LETTER REGARDING REGULATORY REVIEW AND COMMENTS ON DRAFT FINAL
REMEDIAL INVESTIGATION FEASIBILITY STUDY WORK PLAN NCBC GULFPORT MS
3/15/1993
MISSISSIPPI DEPARTMENT OF ENVIRONMENTAL QUALITY

Re: Draft Final RI/FS Work Plan
Naval Construction Battalion Center
Gulfport, MS

Mississippi DEQ Comments
RI/FS Work Plan
Naval Construction Battalion Center
Gulfport, MS

Phase II
COMMENTS FOR THE FINAL VERIFICATION REPORT
NAVAL CONSTRUCTION BATTALION CENTER (NCBC)
GULFPORT, MISSISSIPPI

MAP OF POTENTIOMETRIC SURFACE OF SURFICIAL AQUIFER
NCBC Gulfport
Gulfport, Mississippi

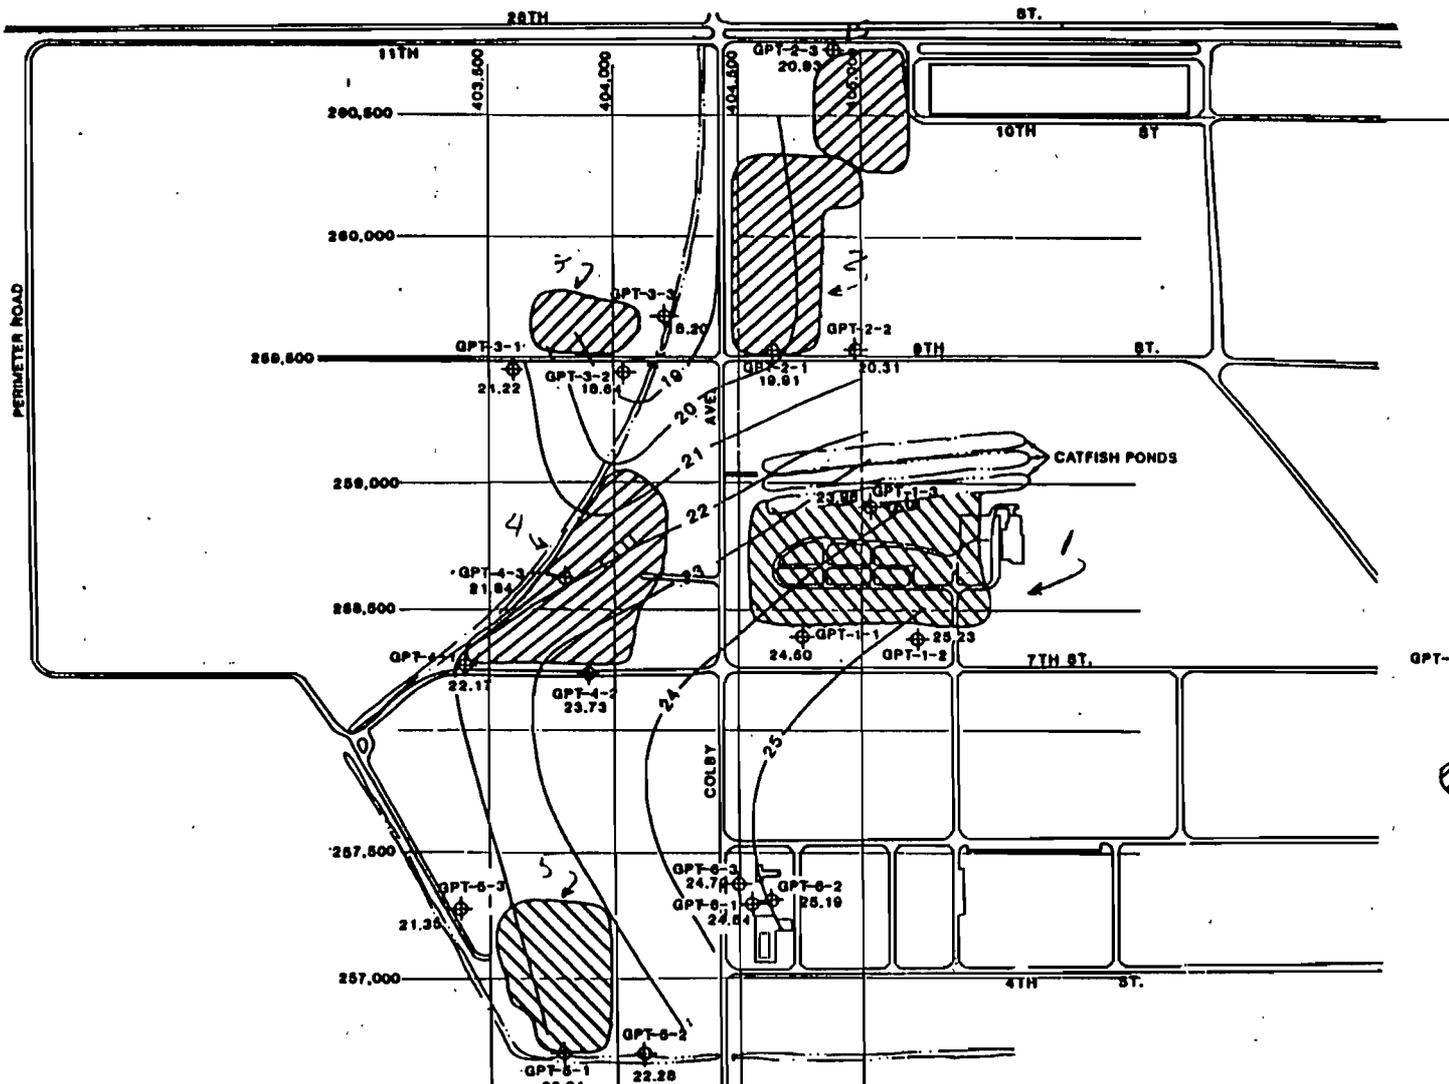
Only one round of water level measurements were taken in the surficial aquifer at the NCBC facility. These measurements indicate that the hydraulic gradient slopes in a direction different than originally presumed (figure 2). This has resulted in the placement of an inadequate number of downgradient monitoring wells at Sites 1 through 5, and possibly at Site 6. The Final Verification Report recommends that before additional monitoring wells are installed at these locations, further rounds of water level measurements should be collected. It was noted in the report that several inches of precipitation had occurred at the facility in the weeks that preceded the water level measurements. This rainfall had the effect of raising water levels to above normal and may have also affected the slope of the potentiometric surface. Quarterly water level measurements would determine if seasonal and/or local effects cause significant variations in the hydraulic gradient and the direction in which it slopes. This information is necessary to determine if future monitoring wells are correctly placed and that an adequate number are installed.

GROUNDWATER MONITORING WELL AND SAMPLING LOCATIONS - SITE 1
NCBC Gulfport
Gulfport, Mississippi

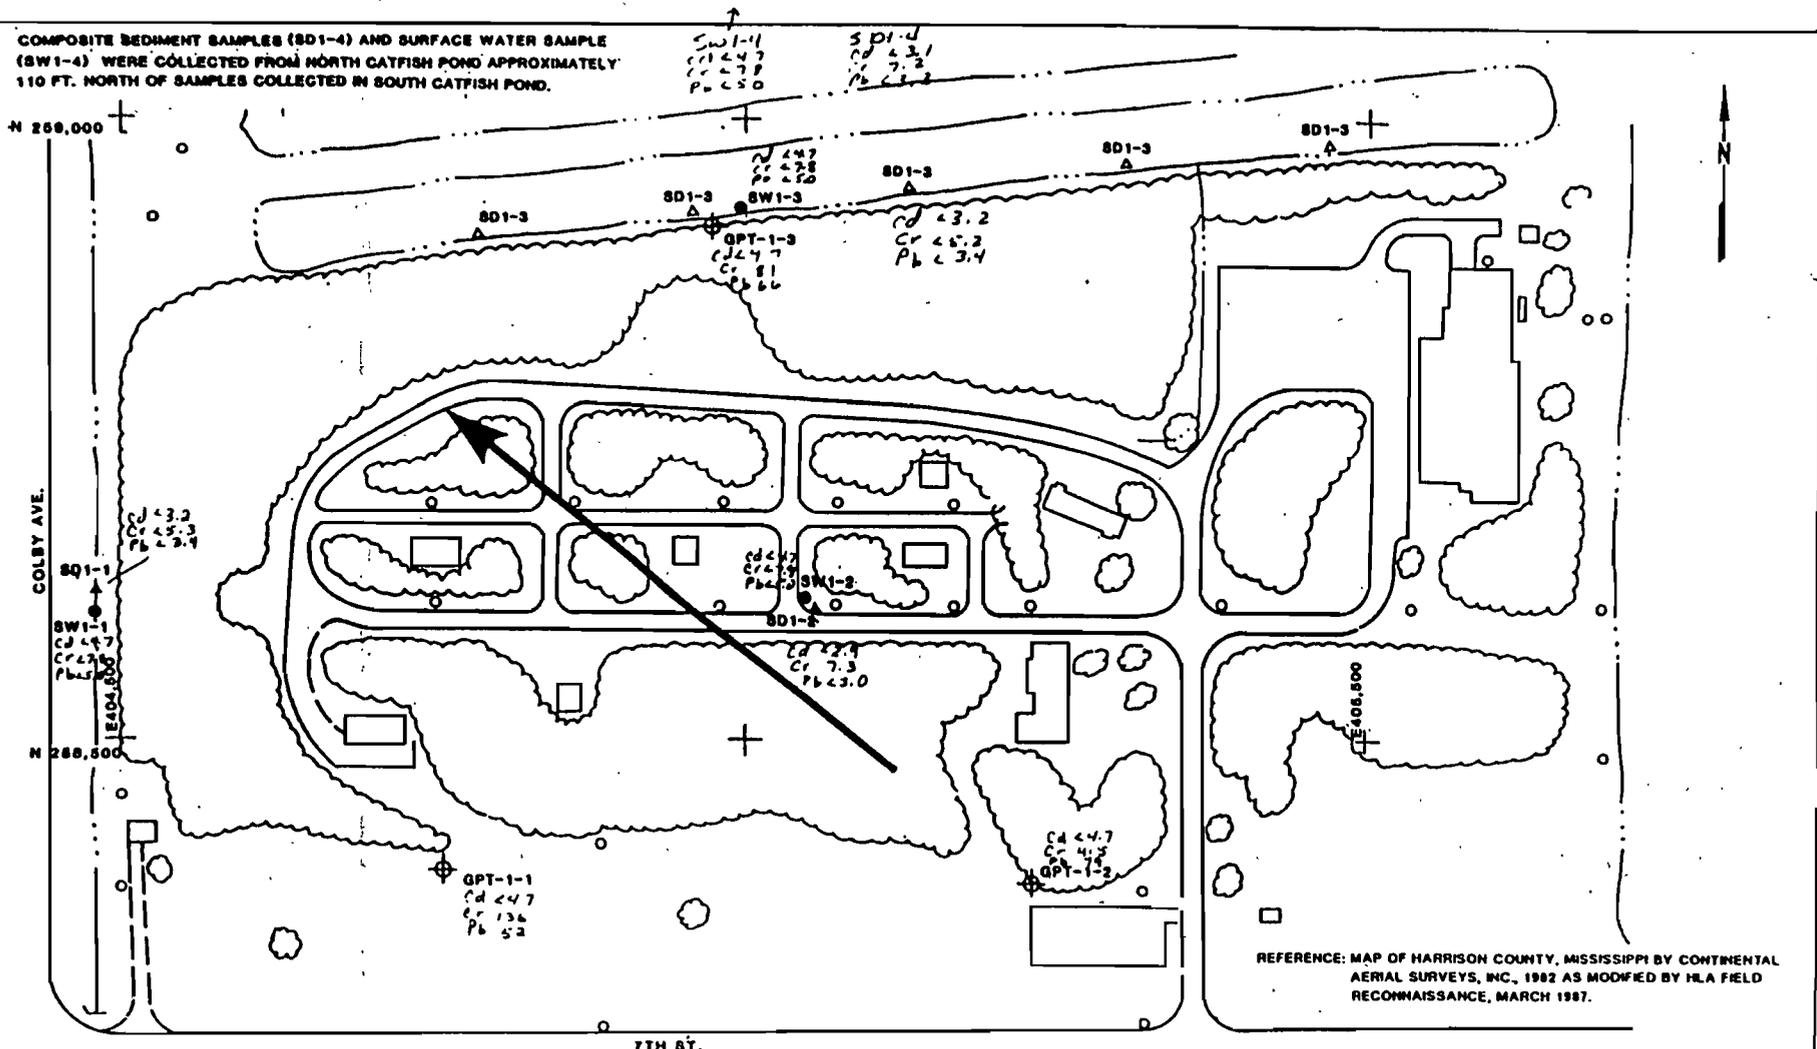
Analytical results for groundwater samples taken from all three monitoring wells at site 1 indicate that levels of chromium and lead are above the Maximum Concentration Levels (MCLs) as specified in the Safe Drinking Water Act (figure 3). The highest concentrations of chromium and lead were encountered in well GPT-1-2. As stated previously, the report recommends that the wells be resampled to verify contaminant concentrations. The installation of additional

downgradient well are necessary pending confirmation of the potentiometric surface configuration.

GROUNDWATER MONITORING WELL AND SAMPLING LOCATIONS - SITE 3
 NCBC Gulfport
 Gulfport, Mississippi

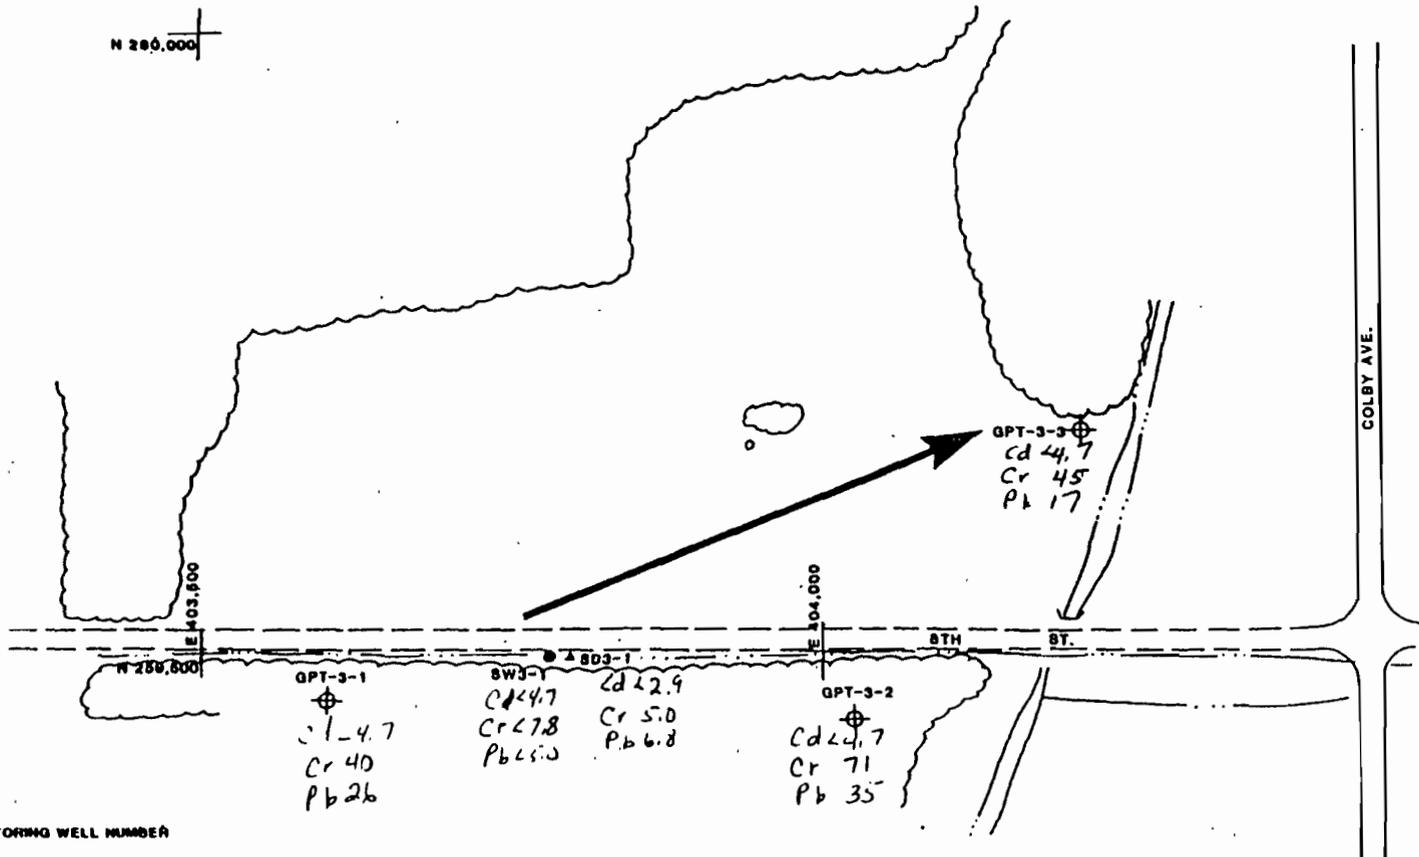
Metals were the only contaminants detected in the groundwater samples from Site 3 (figure 5), and all metals levels were below the MCL. Resampling to verify contaminant concentrations is recommended, as is installation of additional downgradient monitoring wells after confirmation of the configuration of the potentiometric surface.

Harding Lawson Associates	GROUNDWATER MONITORING WELL AND SAMPLING LOCATIONS - SITE 4 NCBC Gulfport Gulfport, Mississippi		
	Engineers, Geologists & Geophysicists			
DRAWN BY 	JOB NUMBER 2176,093.12	APPROVED 	DATE 4/1/87	REVISIONS

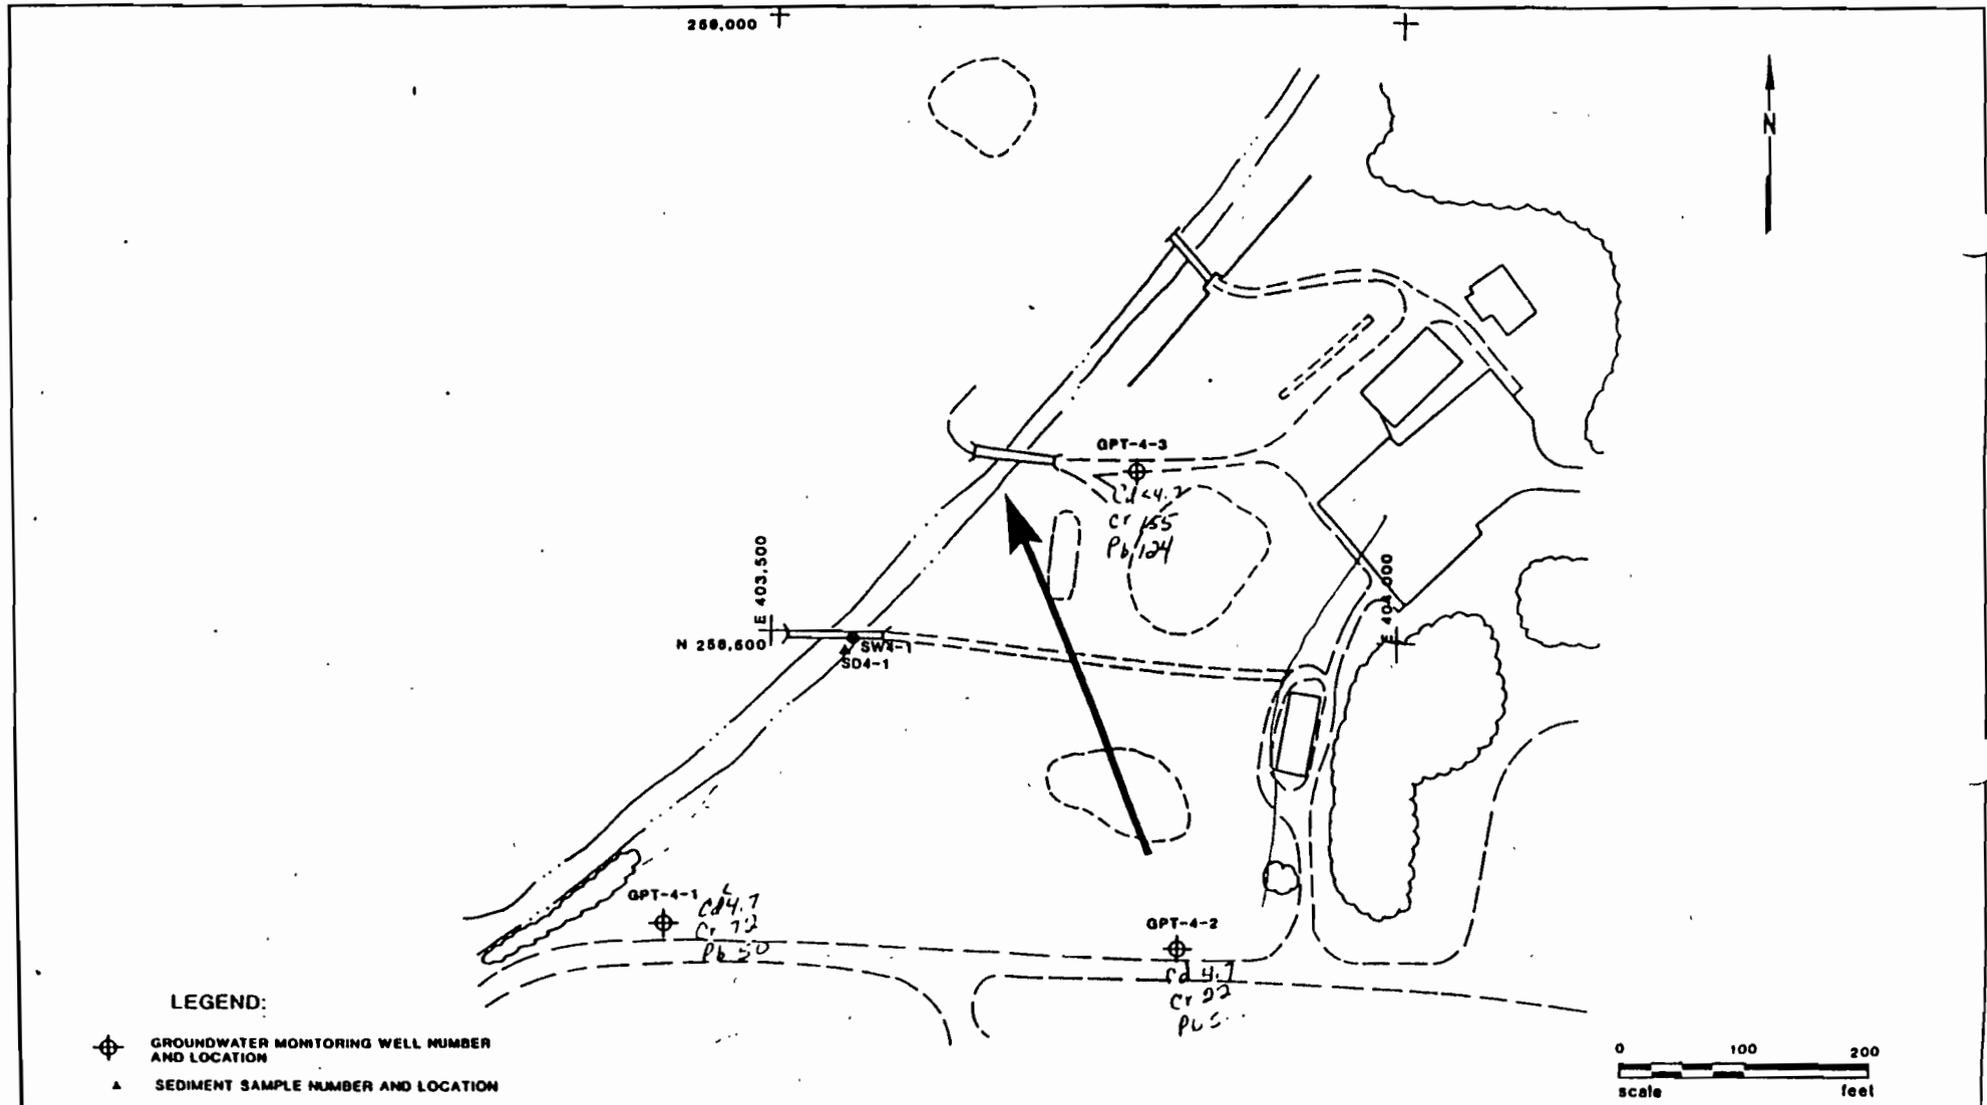
There were no volatile organic, acid-extractable, or base-neutral contaminants above detection limits for all monitoring wells at Site 4 (figure 6). Chromium concentrations for samples taken from wells GPT-4-1 and GPT-4-3, however, were above the MCL of 50 ppb at concentrations of 72 ppb and 155 ppb, respectively. Lead concentrations for the same two wells were 50 ppb and 124 ppb (MCL = 50 ppb). Levels of chromium and lead below the MCL were detected at well GPT-4-2 and levels below the RFI health based criteria were found in sediment sample SD4-1. Resampling of all wells is recommended to confirm these contaminant levels. Additional downgradient wells are needed, but as always should be installed only after further groundwater measurements confirm slope of the potentiometric surface at this site.

Another area of concern involves the past practice of disposing of MEK at Site 4. This compound was not included in the list of chemical parameters analyzed for at this facility. MEK should be added to this list and analyzed for in any future sampling events.

GROUNDWATER MONITORING WELL AND SAMPLING LOCATIONS - SITE 5

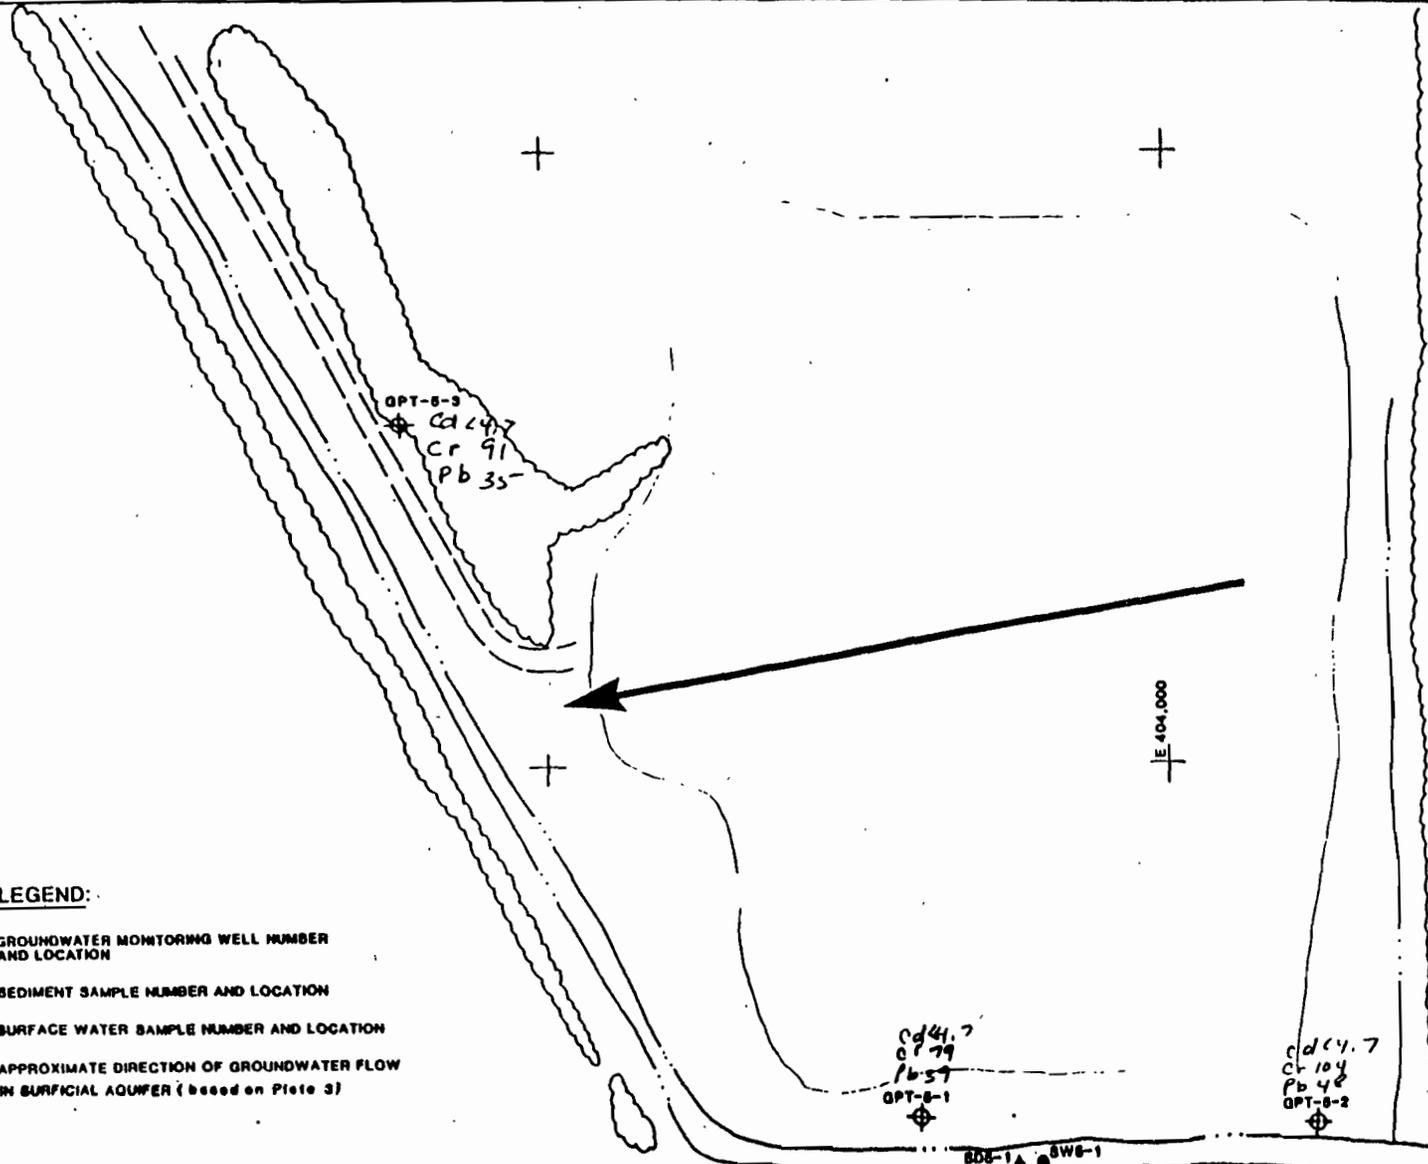
Elevated levels of chromium were detected at Site 5 (figure 7). Analytical results for groundwater samples from GPT-5-1, GPT-5-2 and GPT-5-3 indicate chromium concentrations of 79 ppb, 104 ppb, and 91 ppb, respectively. Lead levels were all below the MCL, but are high enough (38 to 48 ppb) to be of concern. As for the other sampling sites, resampling as recommended in the report should be done, but in a manner that reduces the dilution of groundwater samples. Additional downgradient wells are needed.

As at Site 4, the disposal of MEK is of concern and should be added to the list of chemical parameters analyzed for in future sampling events.
